**Subject:** Water Treatment Plant Change Order No. 02

## CHANGE ORDER NO. 2

Owner: City of Minnetrista  
Engineer: AE2S  
Contractor: Magney Construction, Inc.  
Project: Minnetrista Woodland Cove WTP Project  
Contract Name: Contact No. 1 – Minnetrista Woodland Cove WTP Project  
Date Issued: 5/12/2026  
Owner's Project No.:  
Engineer's Project No.: P05355-2023-002  
Contractor's Project No.: 00624  
Effective Date of Change Order: 5/18/2026

Field Order No.: FO-6

**1** **OUTLET CONTROL STRUCTURE**  
 C703 SCALE: NONE

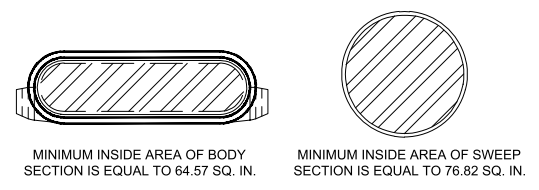
Description of Interpretation or Change:  
Standard details and sitework piping changes.

SHEET TITLE: **SITE PIPING - PLAN & PROFILE - STORM SEWER**

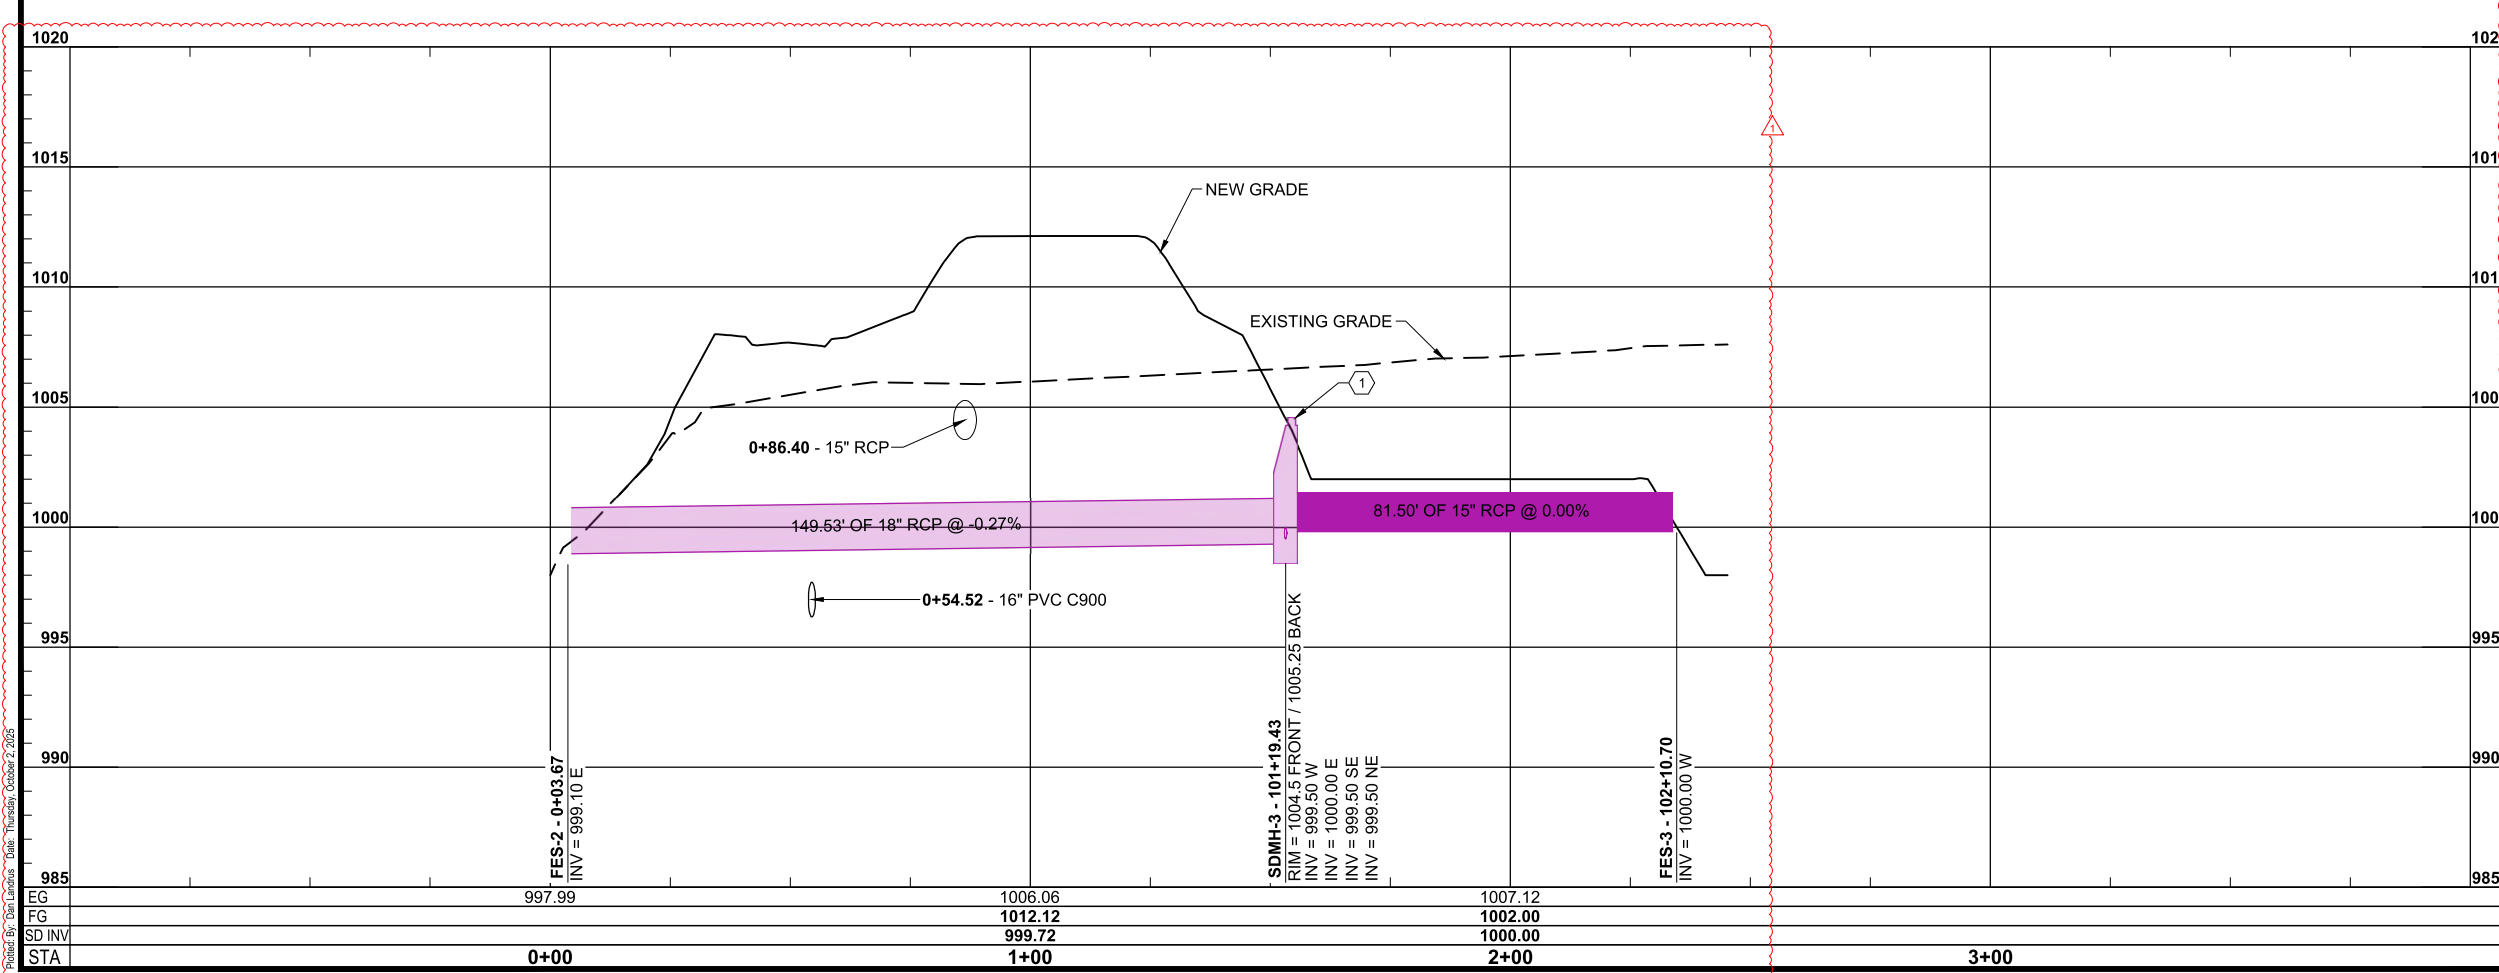
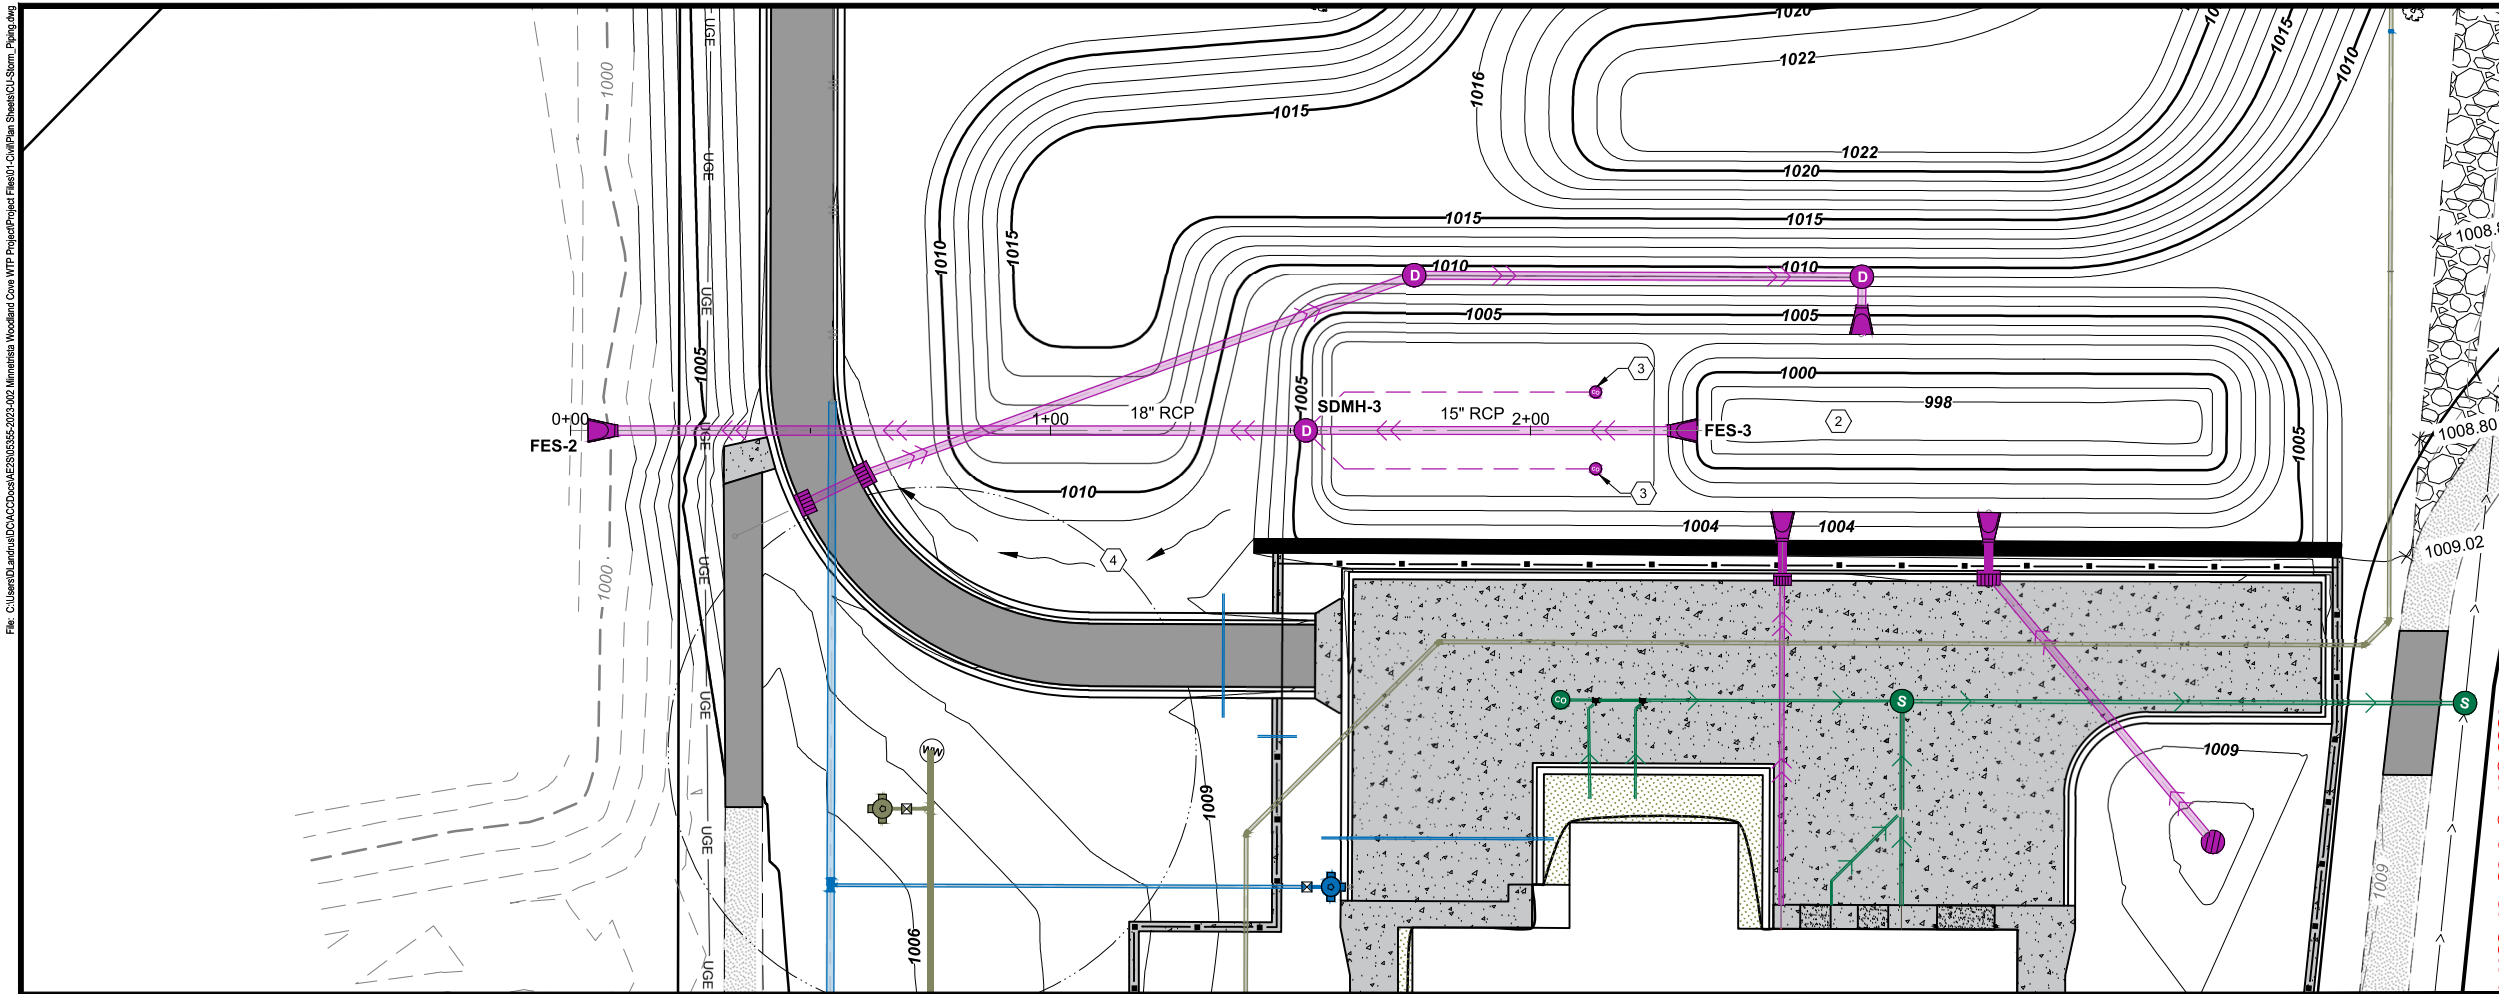
Magney Construction, Inc. is pleased to present the following cost to include the necessary labor, material and equipment to make the civil site changes identified in Field Order No. 06. This includes reducing the draintile size at the ponds from 6-in to 4-in, adding cleanouts for the draintile, and increasing the amount of filtration mulch in the filtration basins. The cost for this change has been summarized below.

- GENERAL NOTES**
- INSTALL ARTICULATED CONCRETE BLOCK MAT AT ALL STORM OUTLETS. SEE DETAIL 1/C708.
  - TRANSITION FROM PERFORATED PVC DRAIN TILE TO SOLID WALL PVC SCH 40 WHEN DRAIN TILE IS INSTALLED OUTSIDE OF FILTRATION BENCH.
- CONSTRUCTION NOTES**
- OUTLET CONTROL STRUCTURE: SEE DETAIL 1/C703.  
 GRATE TOP - INSTALL SALVAGED GRATE  
 RIM (FRONT/LOW) = 1004.5  
 RIM (BACK/HIGH) = 1005.25  
 6" THICK X 48" WIDE WEIR = 1003.0
  - STORM BASIN:  
 BOTTOM: 998.0  
 NWL / TOP OF SAND: 1002.0  
 DOLI WATER QUALITY VOLUME: 1002.9  
 100 YR HWL: 1004.2  
 TOP: 1008.0
  - INSTALL FILTRATION MEDIA AND 4" DRAIN TILE PER DETAIL 3/C706  
 INSTALL END OF LINE CLEAN OUT PER DETAIL SAN-10 ON C708.  
 DRAIN TILE INVERT AT CLEAN OUT = 999.75'
  - EMERGENCY OVERTFLOW: 1008.0'  
 CONTRACTOR TO GRADE EOF AREA TO ELEVATION 1008.0 FROM TOP OF POND TO CATCH BASIN.

PROJECT NO: P05355-2023-002		SHEET DESIGNATOR:	SHEET NO:
DATE: JULY 2025		SW	C219
ALT. PROJECT NO: 000-0000

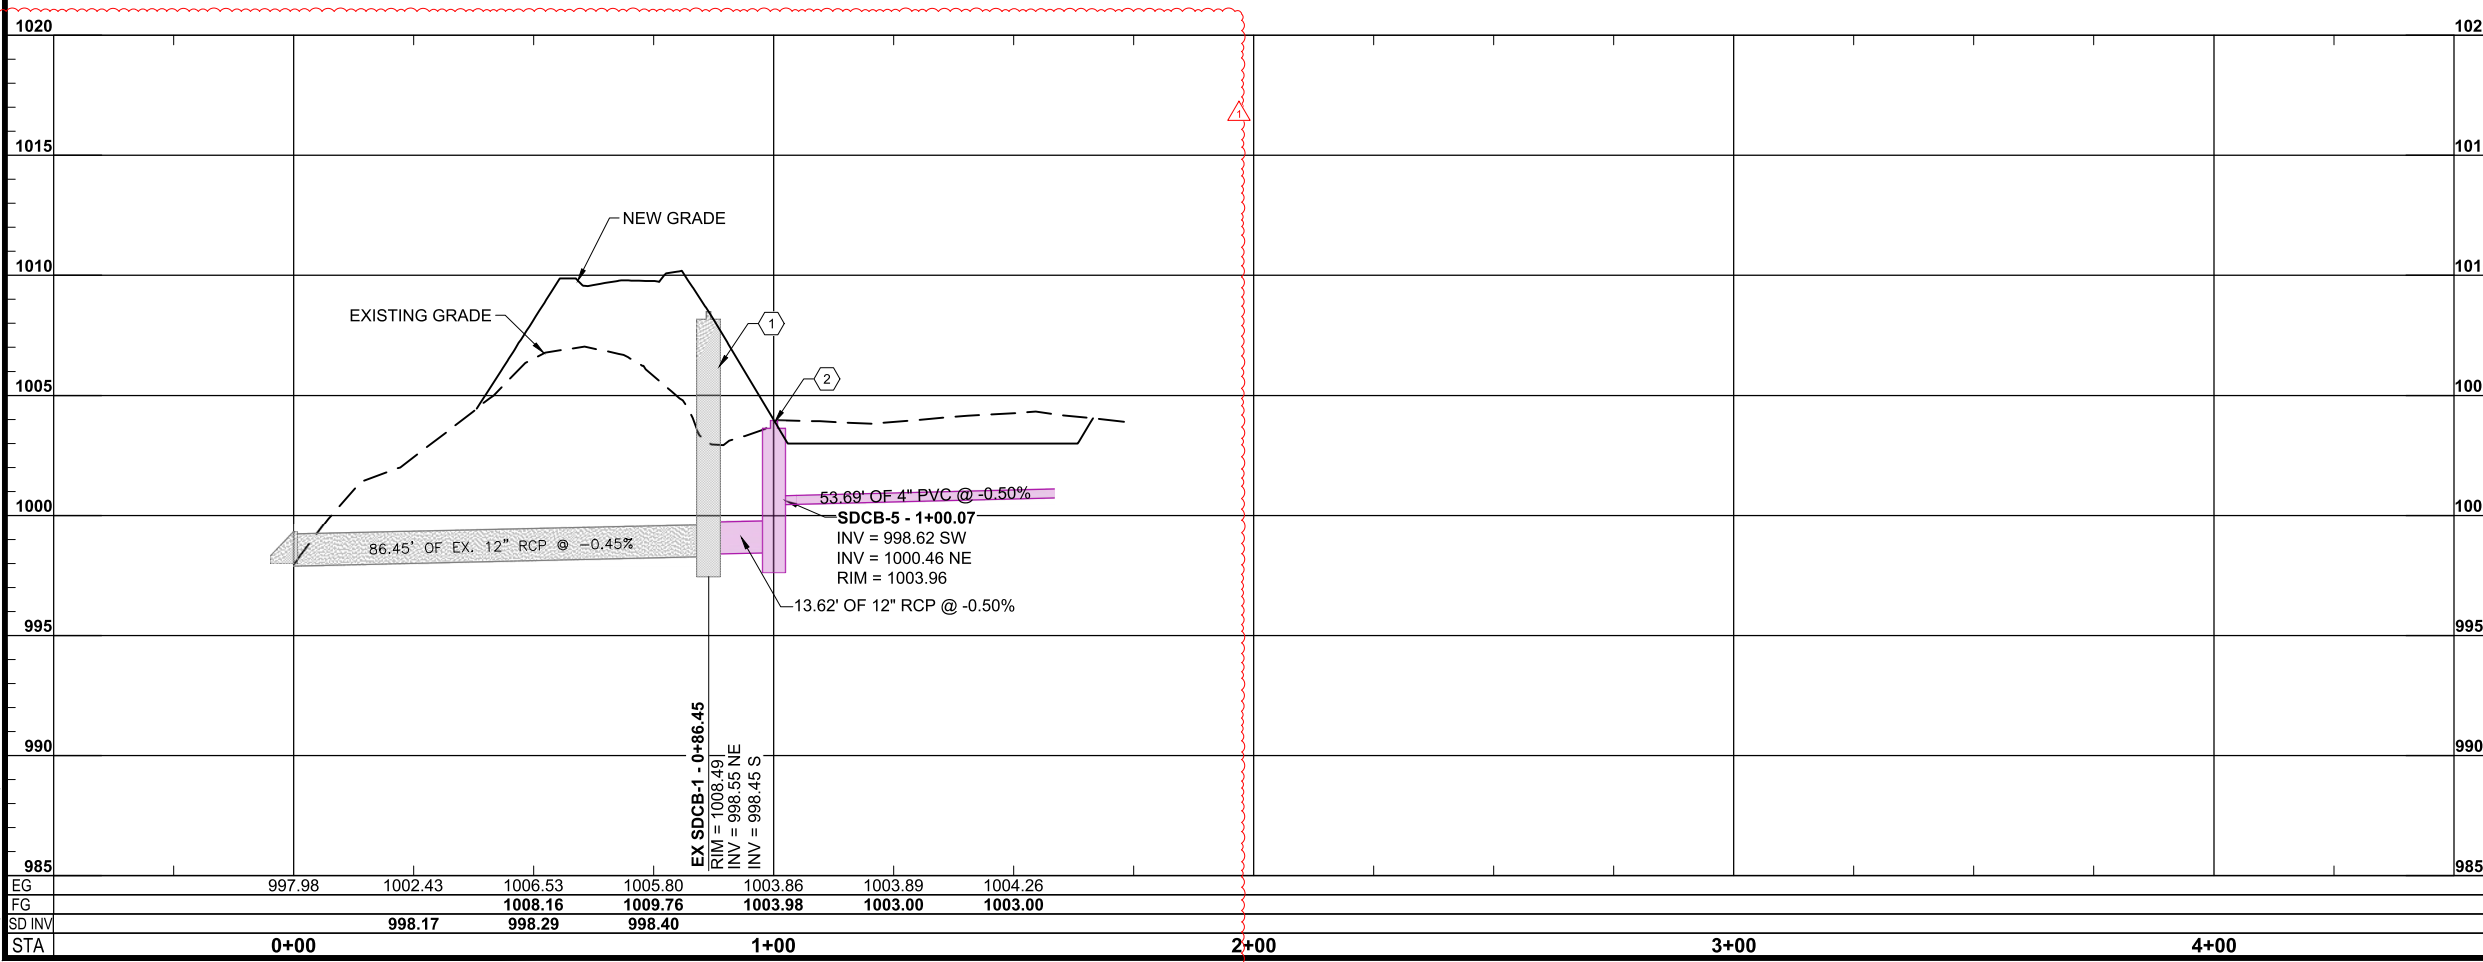
- 1 ADJUST STRUCTURE TO NEW GRADE. INSTALL CASTING PER DETAIL STO-01 ON SHEET C702
- 2 INSTALL BEEHIVE GRATE
- 3 FILTRATION DITCH:  
 INSTALL FILTRATION MEDIA AND 4" DRAIN TILE PER DETAIL 3/C706  
 INSTALL END OF LINE CLEAN OUT PER DETAIL SAN-10 ON C708.  
 DRAIN TILE INVERT AT CLEAN OUT = 1000.75'
- 4 EMERGENCY OVERFLOW: EXISTING DRAINAGE PATH

**3** **FILTRATION BASIN MEDIA AND DRAINTILE**  
 C706 NO SCALE

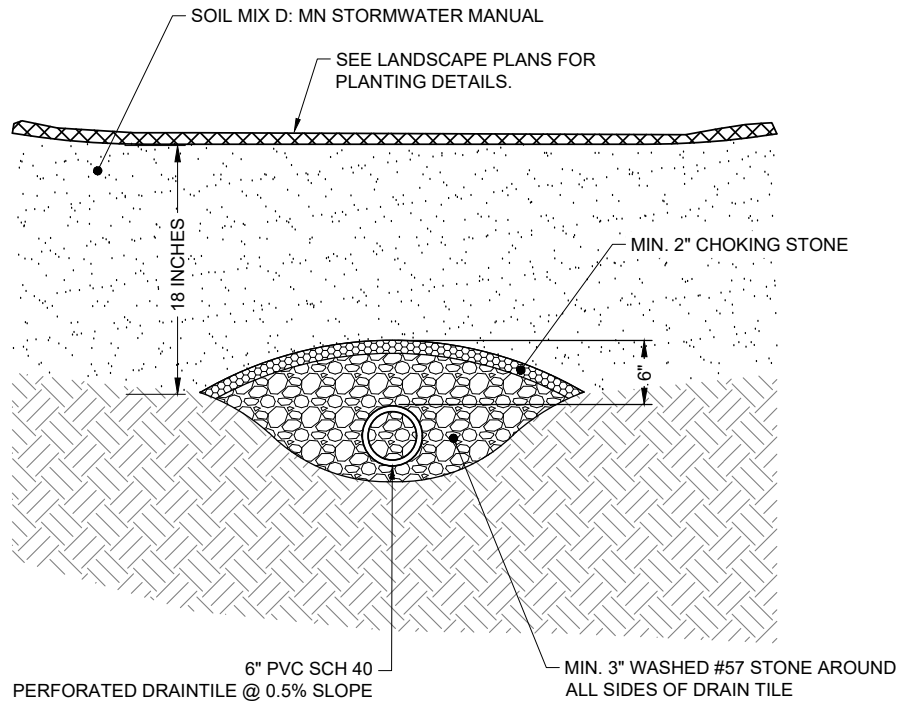
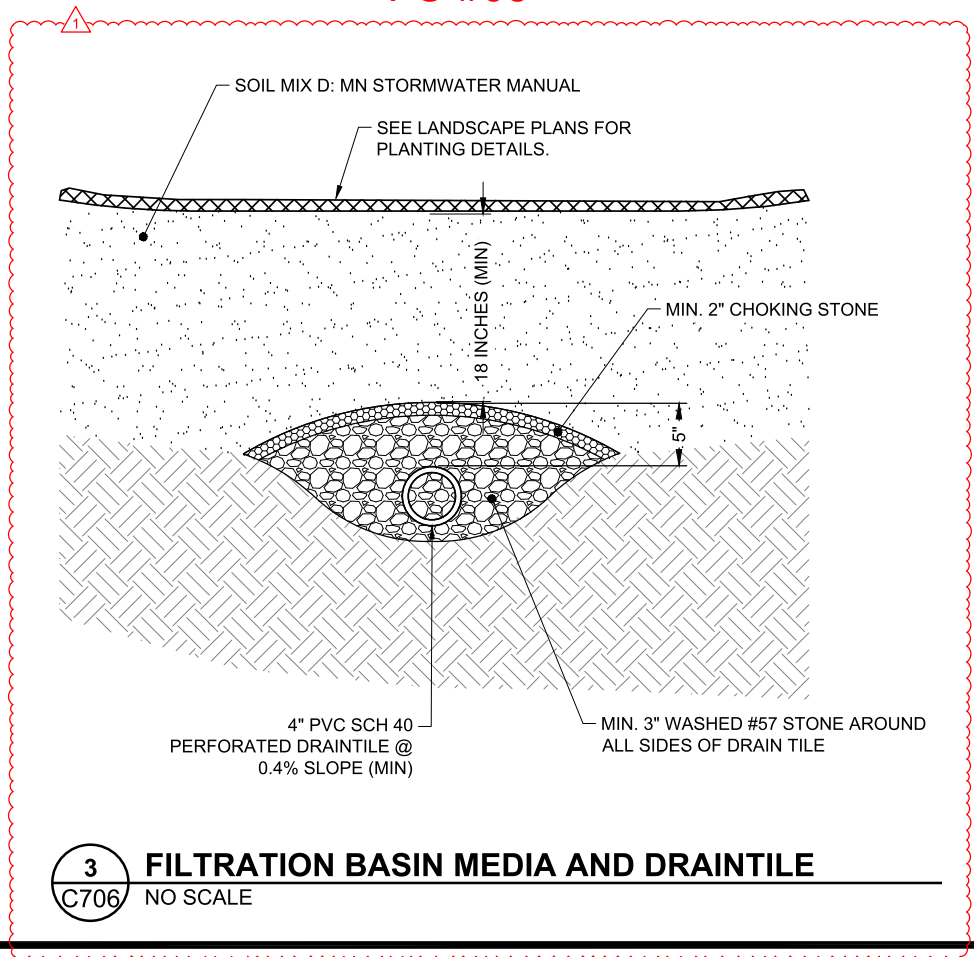
What is the targeted sand thickness for the Filtration Basin? The base-bid drawings show 18” from bottom of the landscaping to the top of the subgrade. But, the Field Order #06 drawings move that 18” dimension to be to the top of the choking stone. Please clarify how much sand is desired where there isn’t drain tile.

Can you get a clarification from SRF on what their targeted sand thickness is for the filtration basin? The base bid drawings show 18" from the bottom of the landscaping to the top of the subgrade but the FO-06 drawings move that dimension to be to the top of the choking stone and they don't really clarify how much sand they want where there isn't draintile.

The Field Order 6 detail is accurate. 18” of media must be above the choking stone. Where there is not tile, the 18” minimum media depth still holds. I would anticipate a depth of 18”-24” where there isn’t drain tile.
